Addendum No. 1

TRUCKEE CANYON WATER SYSTEM EXPANSION

PWP Bid No. WA-2016-094
March 07, 2016

A ELECTRICAL PLAN
E101 1/2" = 1'-0"

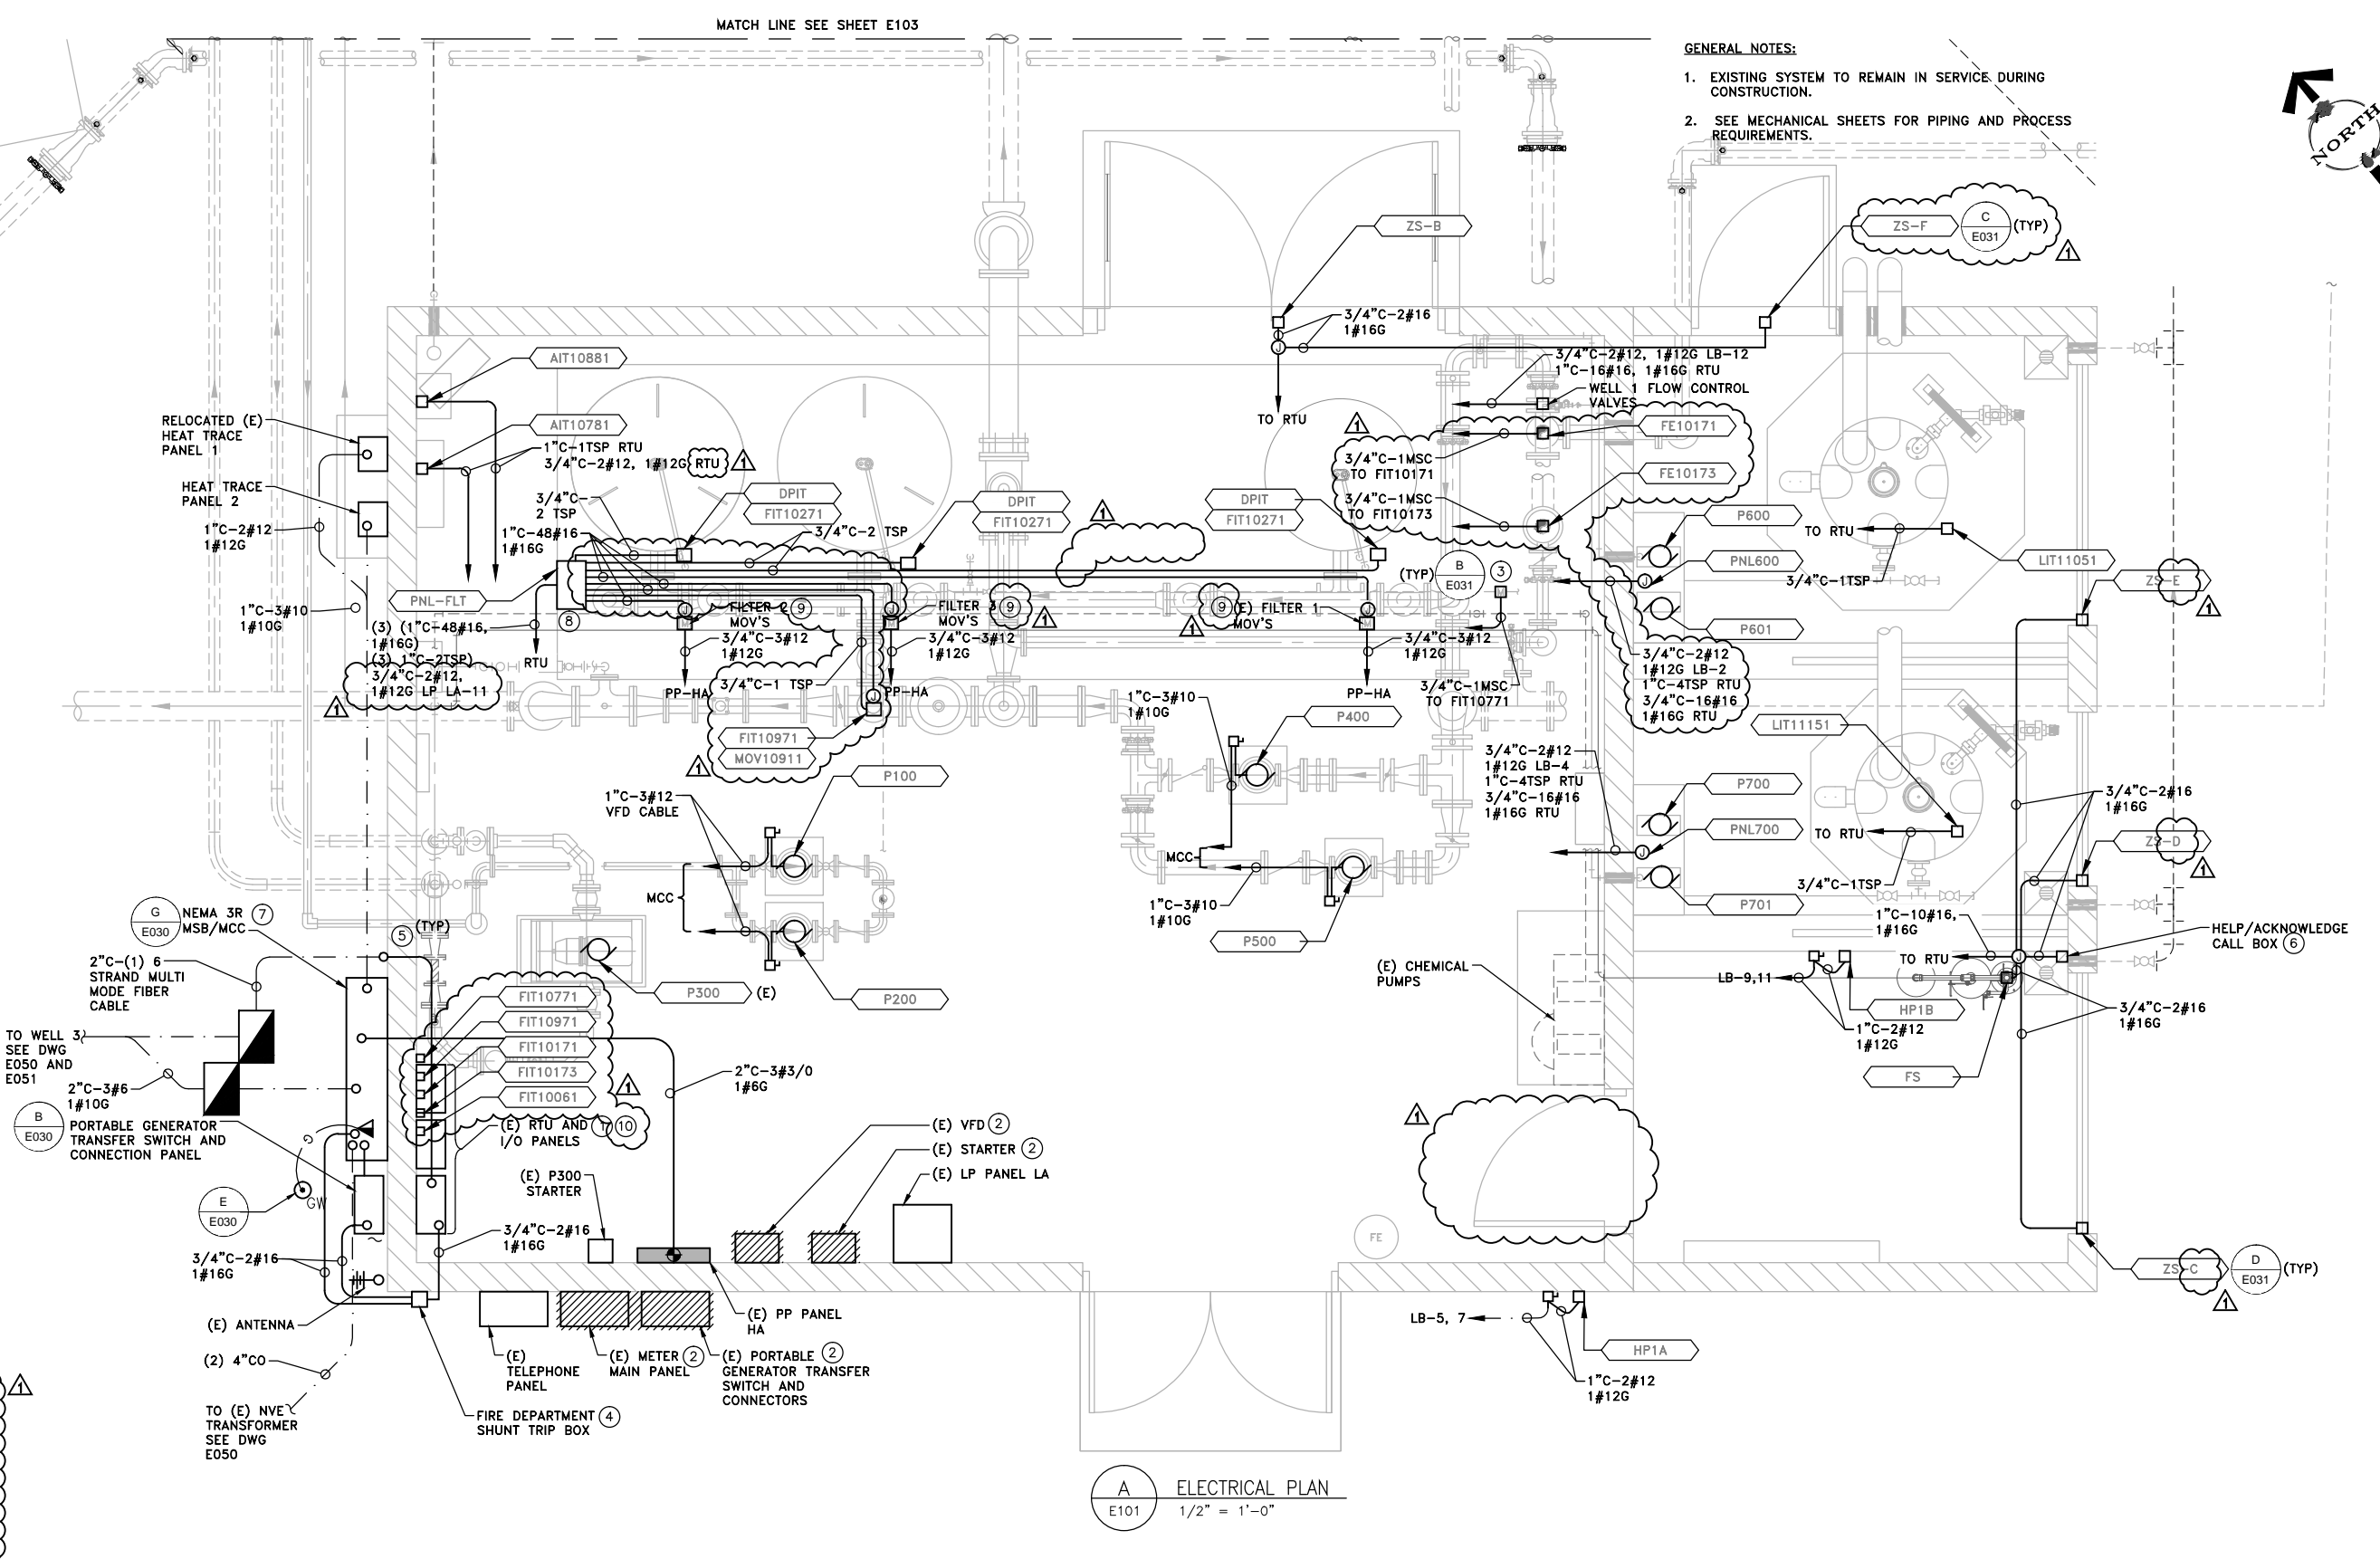
Sheet Number	Page(s)	Description of amendment
Drawing E001	50	See attached drawing with revision cloud indicating amendments.
Drawing E030	54	See attached drawing with revision clouds indicating amendments.
Drawing E101	58	See attached drawing with revision clouds indicating amendments.
Drawing I101	63	See attached drawing with revision clouds indicating amendments.

TYPICAL DRAINAGE OUTLET

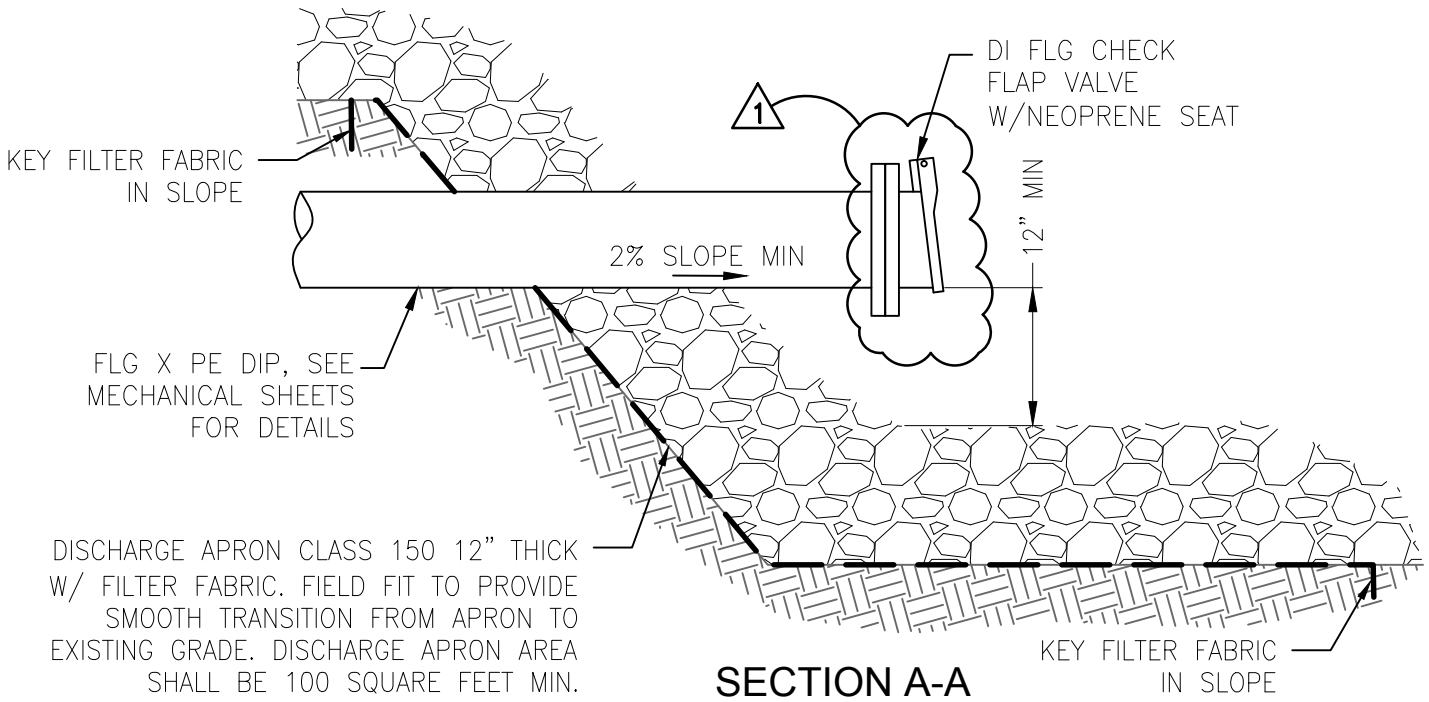
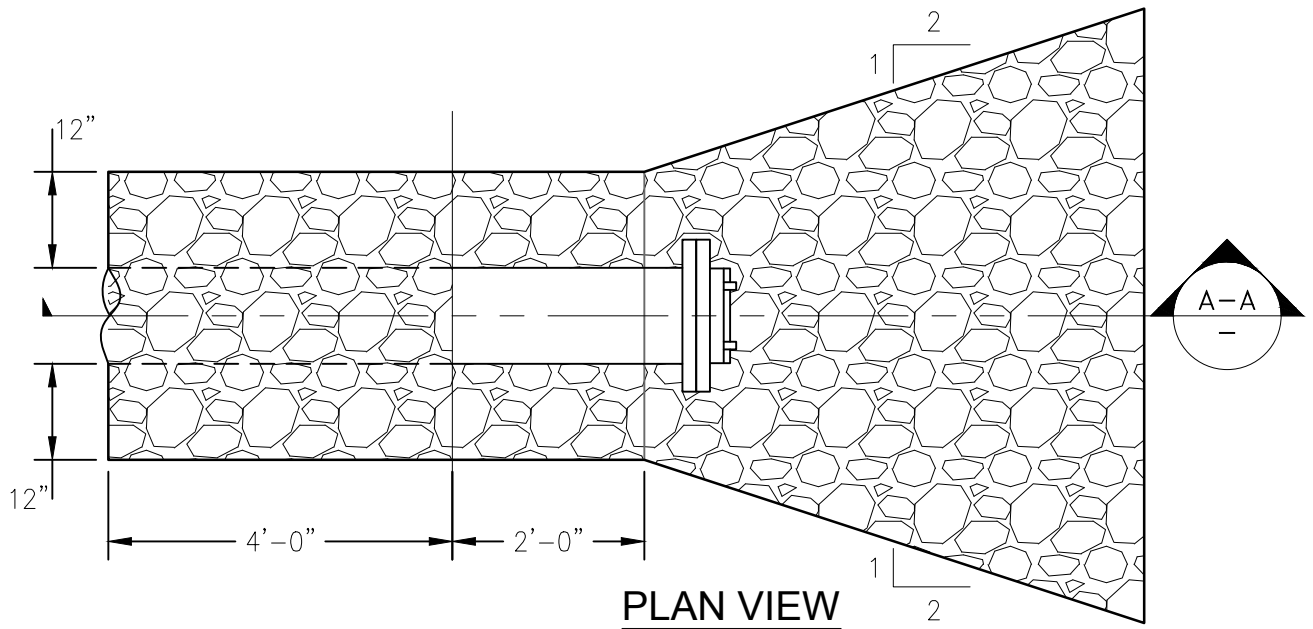
Sheet Number	Page(s)	Detail	Description of amendment
C007	15	C615/TYP	Ductile iron check flap valve with neoprene seat sloped to prevent storing water in the discharge pipe.
S102	44	D/S102	Ceiling insulation callout in detail D/S102 changed to “Insulation, see 1/A101 for detail”
S103	45	B/S103	Gable end vent callout in detail B/S103 changed to “Gable end vent. Min size 28" x 24"w/ min 50% NFA. See spec section 11010”

D BUILDING SECTION
S102 1/4" = 1'-0"

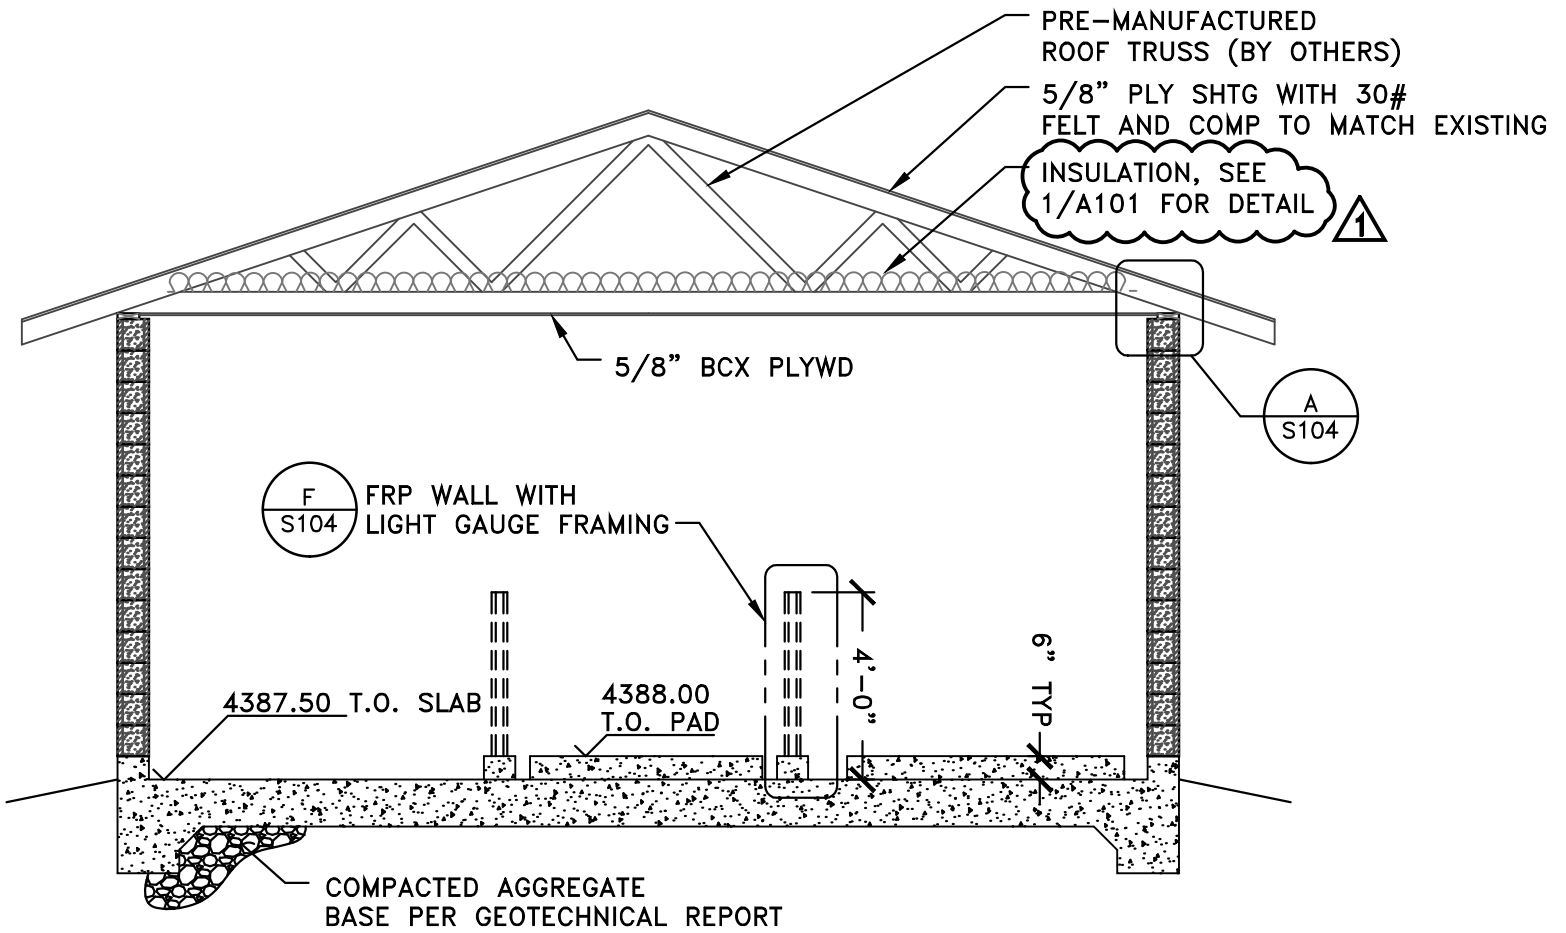
Question No. 7: A101 calls out R-30 Batt insulation, sheet S102 calls out Fiberglass batt insulation to match existing R-19 minimum. What is existing, and which sheet is correct?

Response to Question No. 7: The contractor shall install R-30 Batt insulation for the ceiling. Attached is the revised detail D/S102.

B EAST ELEVATION
S103 1/4" = 1'-0"

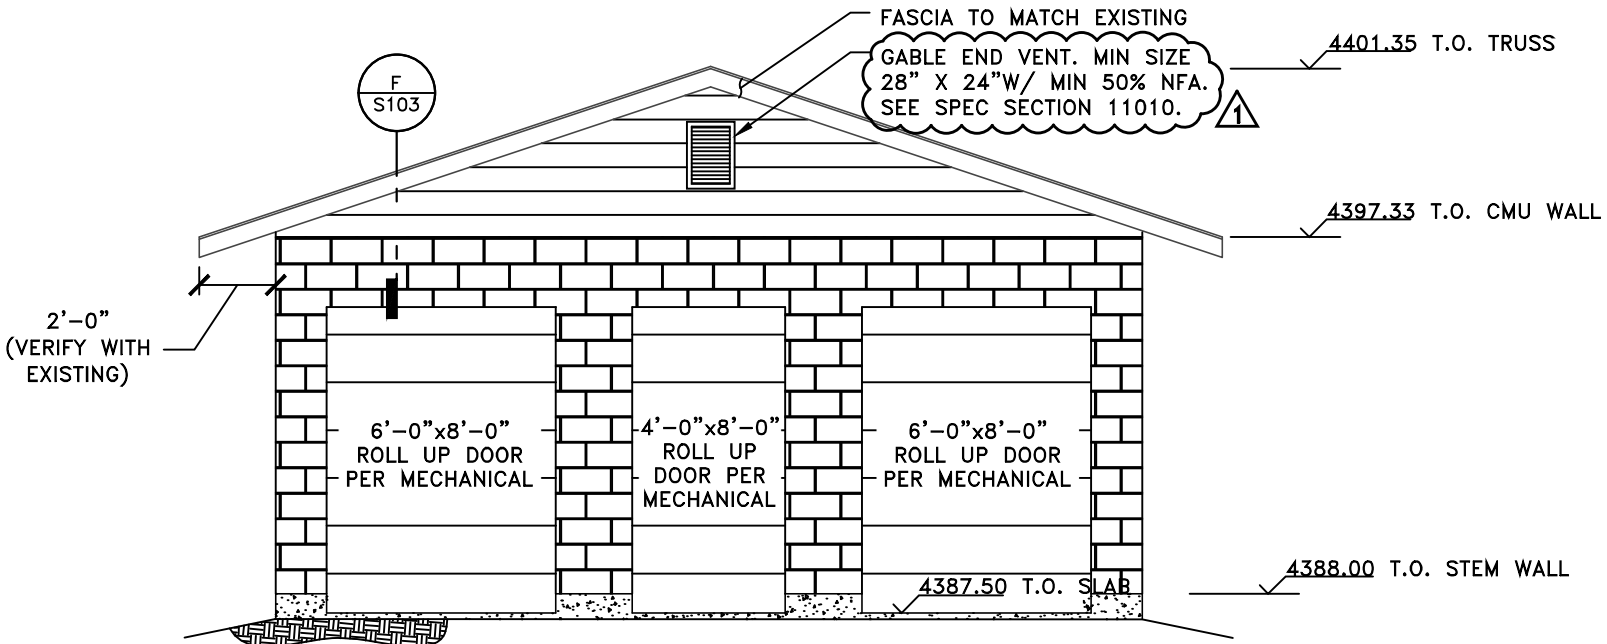
Question No. 9: Detail B/S103 calls out Gable end vent (size per roof venting calculation). Who is responsible for the calculations/vent sizing?

Response to Question No. 9: Please see attached revised detail B/S103.
